Subject: Final Environmental Assessment and  
Finding of No Significant Impact for  
Village Park Connector Road  
Waipahu, Ewa, Oahu, Hawaii  
TMK: 9-4-55: 146; 9-4-02: 28 (por.); 9-4-34: 43 (por.);  
9-4-55: 61 (por.) and 9-4-132: 100 (por.)

**FINAL ENVIRONMENTAL ASSESSMENT  
AND FINDING OF NO SIGNIFICANT IMPACT**

**(Village Park Connector Road)  
Waipahu, Ewa, Oahu, Hawaii**

**FIGURE 2-2  
PROPOSED CONNECTOR  
ROAD SECTION**

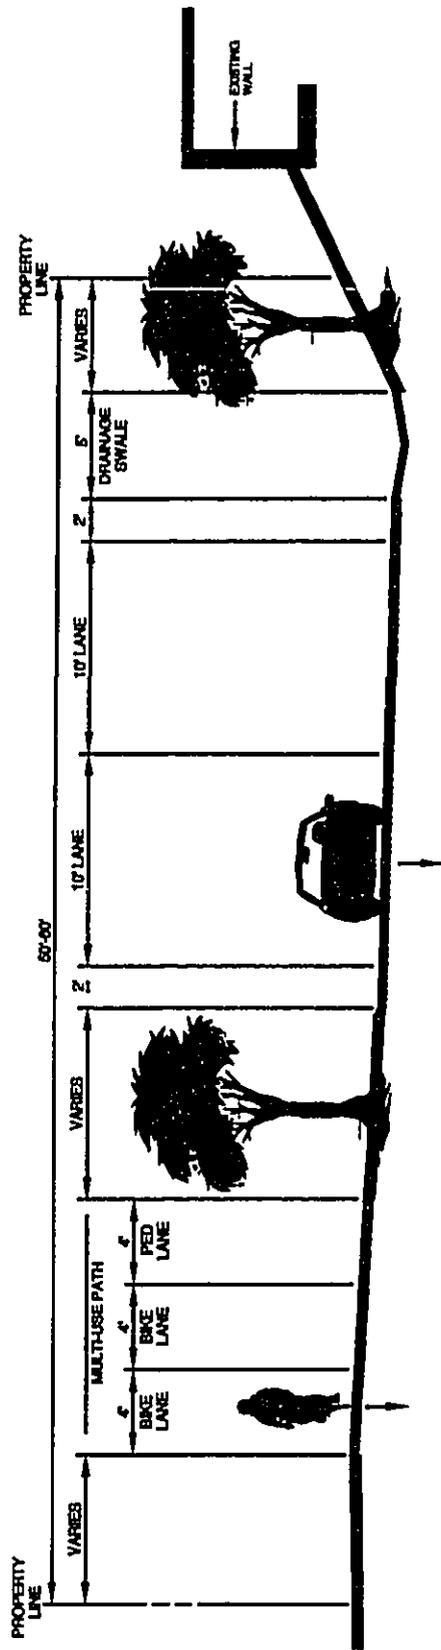
1. Please describe whether the screen wall shown in figure 2-2 will be constructed along the entire length of the Village Park Connector Road. What is the purpose of the screen wall?

2. On Page 2-4, Figure 2-2, Proposed Connector Road Section, should indicate the direction of the view.
3. Once the subject road is completed, motorists may choose to go to Honolulu via Kupuna Loop, Village Park Connector Road, Honowai Street, Kunia Road and the H-1 Freeway. The level of service at the intersection of Kunia Road and Honowai Street should be determined to assess the likelihood of this route being used.

The screen wall shown in figure 2-2 was intended to act as a sound barrier between the proposed connector road and the adjacent properties. However, based on a traffic noise study conducted for the project site using predicted future traffic noise levels projected to the year 2020, the noise level along the proposed connector road should not exceed 65 Ldn. Therefore, traffic noise mitigation measures, such as the screen wall, will not be required at this time.
2. Please illustrate the visual impacts of the proposed screen wall. Photos of existing conditions taken from public viewpoints are helpful in evaluating visual impacts. Renderings of the proposed screen wall superimposed on photos of existing views should

The Final EA will include section arrows on Figure 2-1 to indicate direction on Figure 2-2.

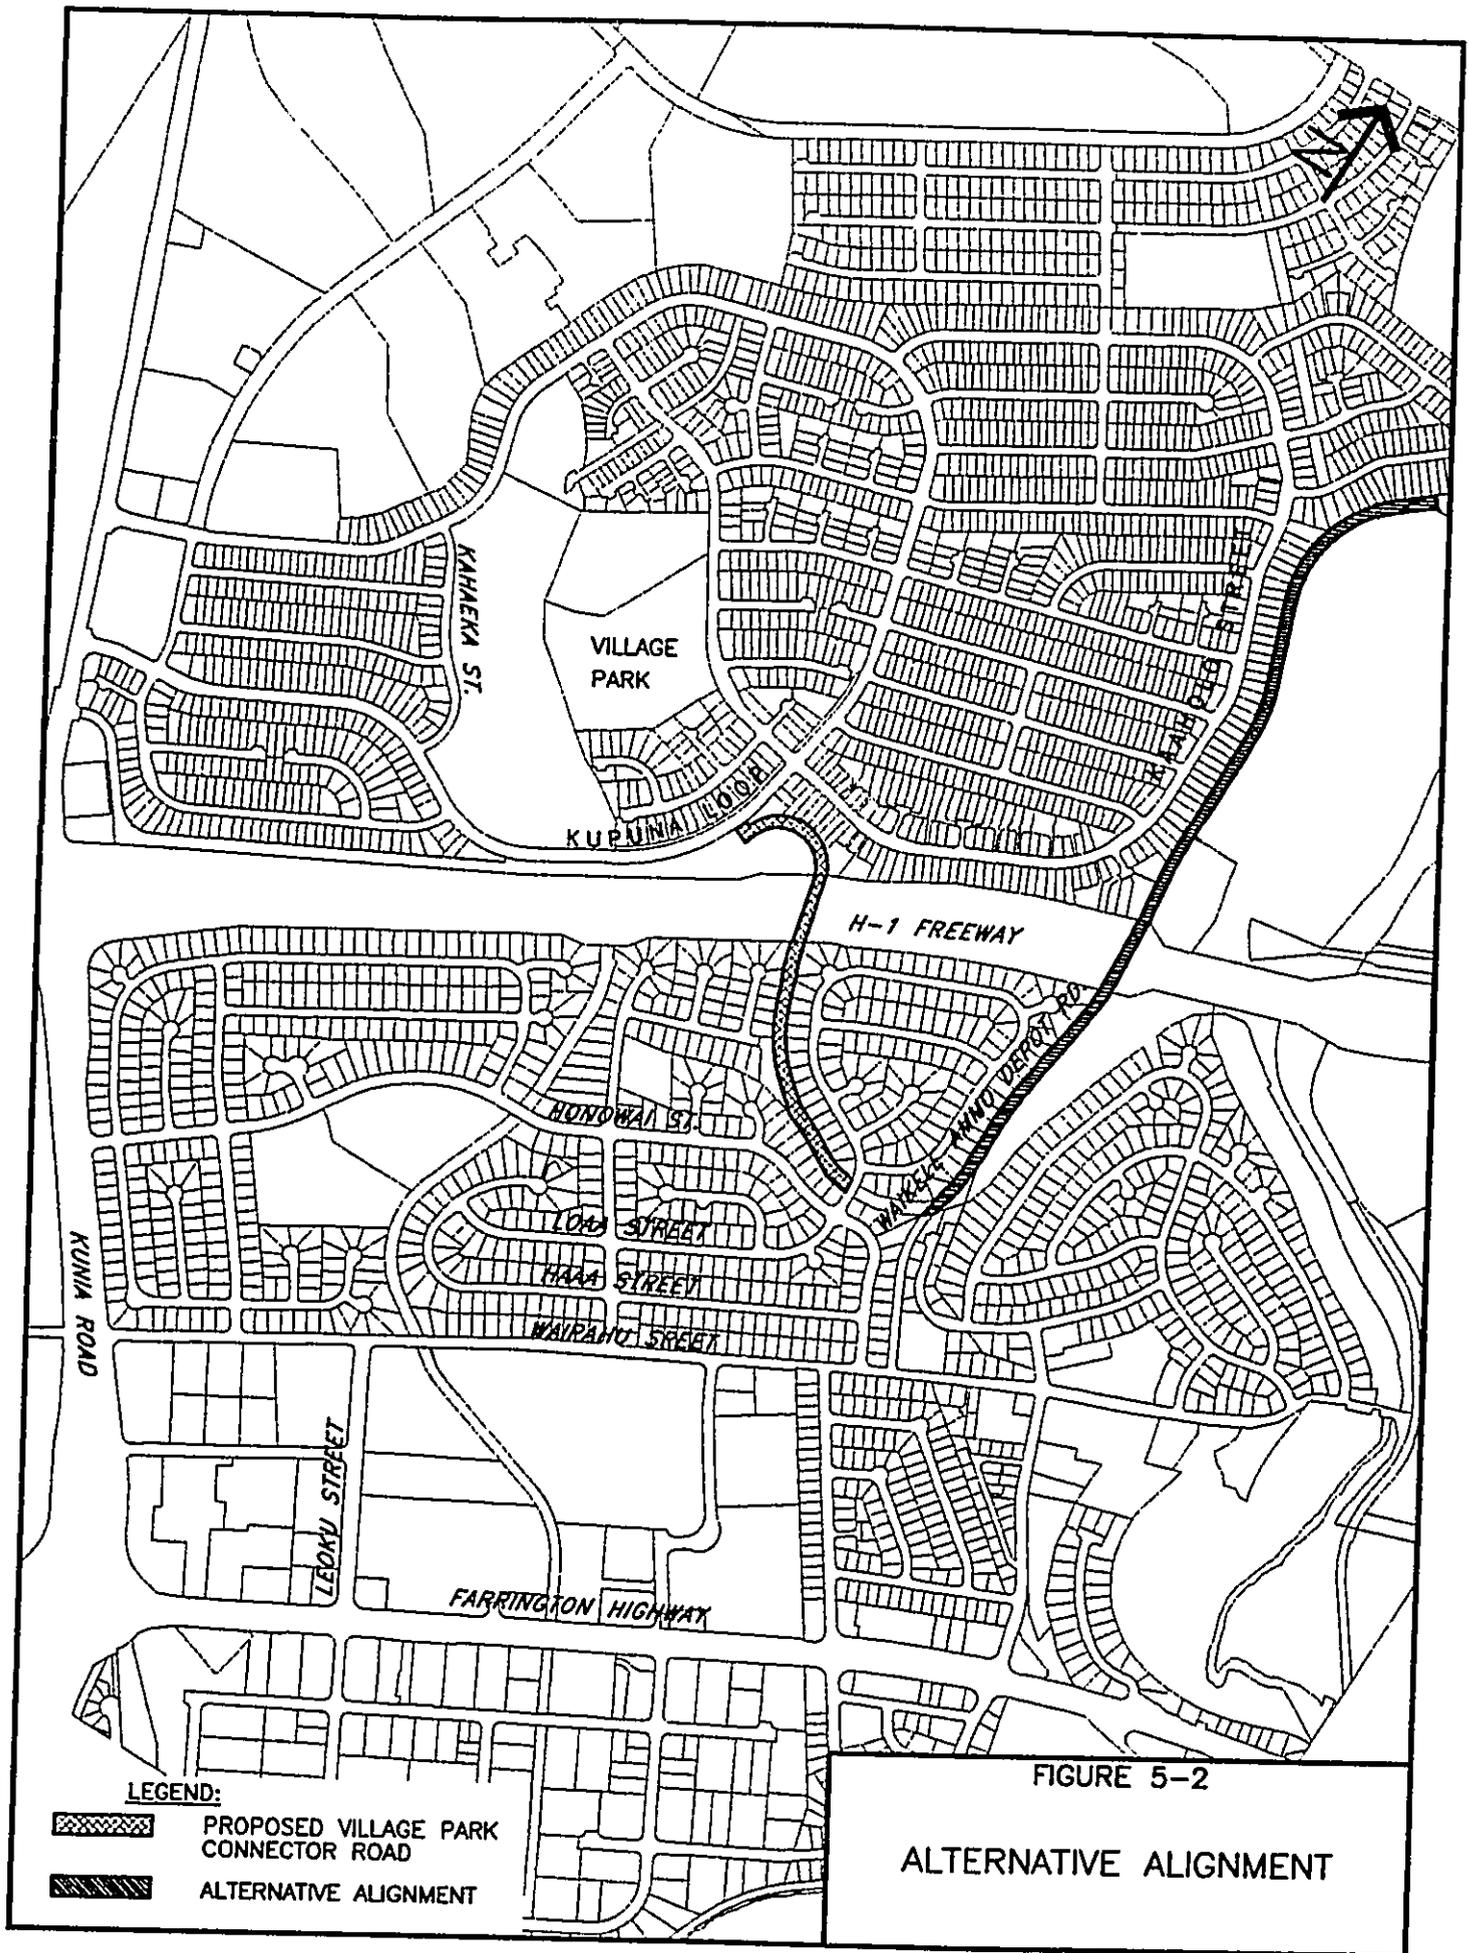
7. The first sentence in Section 5.3 Bike Path Alternative (Page 5-2) should be clarified to indicate that the bike path alternative is shown in Figure 5-1 and the multi-use path configuration is shown in Figure 2-2.

7. *The first sentence in Section 5.3 (Bike Path Alternative) on page 5-2 should be clarified to indicate the bike path alternative is shown on Figure 5-1 and the multi-use path on Figure 2-2.*

The Final EA will include the following clarification: "Construction of two 4-foot wide bike lanes on each side of the connector road with a 4-foot wide walkway on one side (see Figure 5-1) was considered as an alternative to the multi-use path configuration shown on Figure 2-2 in Chapter 2."
